**City of Richmond**  
Urban Development Division

**Request for  
General Compliance**

**To:** Development Permit Panel                    **Date:** July 15, 2003  
**From:** Joe Erceg                                    **File:** DP 01-115457  
**Manager,** Development Applications  
**Re:** **Application by Bing Thom Architects for a General Compliance at  
4151 Hazelbridge Way**

BUILDING  
ELEVATION N/S  
#11E  
JUL 15 2003

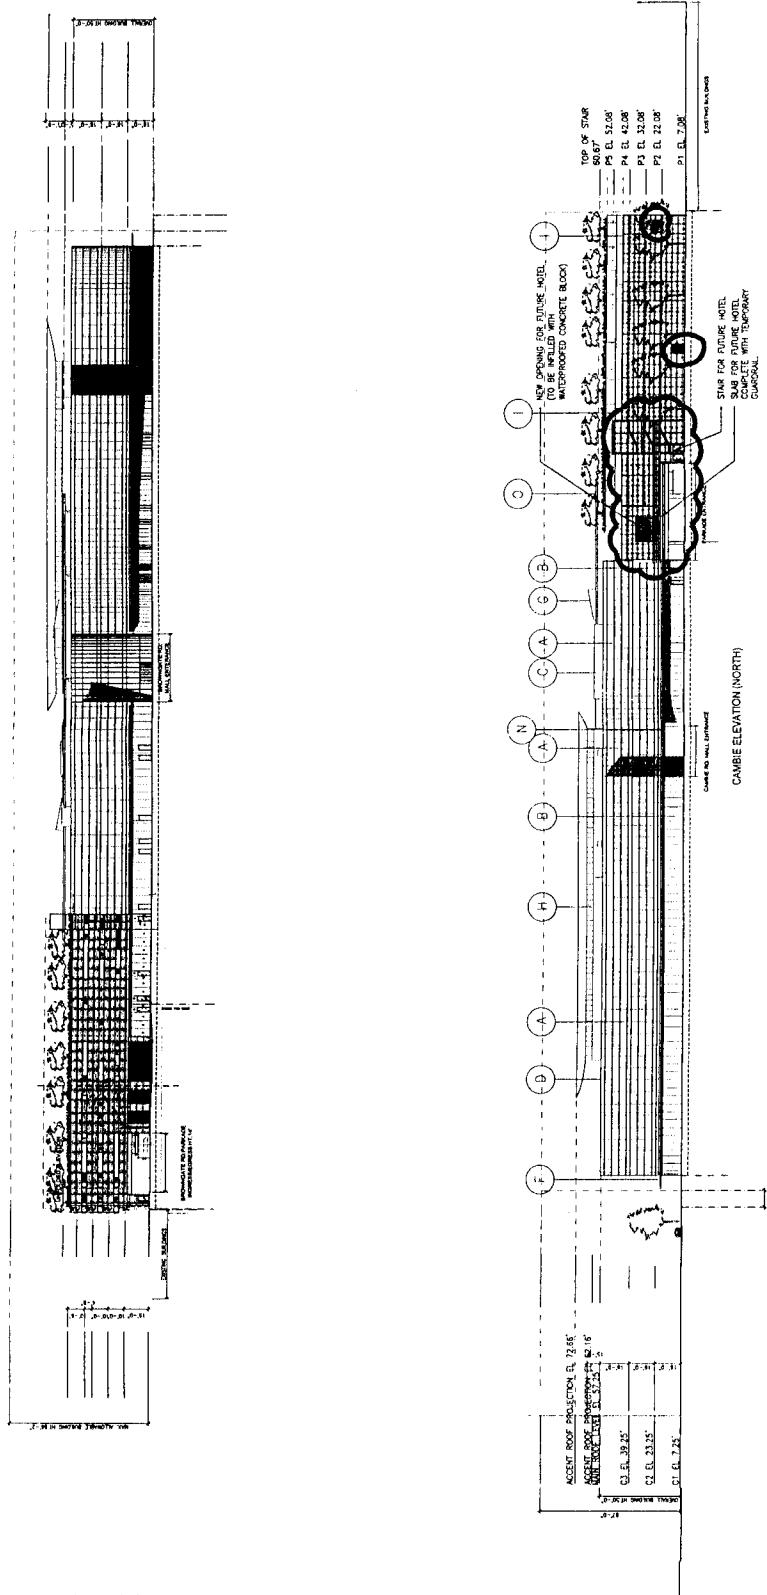
- allow for construction of a stairway attached to the parkade stair structure that will serve as an exit stair to the future hotel. The applicant is also requesting that a portion of the link between the mall and future hotel be constructed now. Once constructed, this link will consist of a concrete slab built over the ground floor drive access fronting Cambie Road and will attach to the proposed exit stair to the future hotel.
- transfer 121.24 m<sup>2</sup> (1305 ft<sup>2</sup>) of community amenity space required in the existing Development Permit for Aberdeen Centre to the future hotel site. The transferred amenity space is to be part of the 518.4 m<sup>2</sup> (5508 ft<sup>2</sup>) of community amenity space required for the rezoning of the hotel site.

4. Proposed exterior modifications must maintain or enhance the quality of the development and must retain the basic form and character of the development. *The proposed exterior modifications relate to the construction of a stair that is attached to the parkade structure and concrete slab over the drive aisle to provide access to the future hotel. Once completed, proposed changes that will be visible along the Cambie Road frontage are the new stair and concrete slab over the Cambie Road parkade drive aisle. Along the west elevation, modifications that will be visible are the new stair, temporary masonry in place of second level glazing and the second level concrete slab. Once constructed, the future hotel will enclose the entire parkade elevation along Cambie Road. The future hotel will also enclose the entire north end of the west elevation. These are minor functional modifications that retain the basic form and character of the development.*
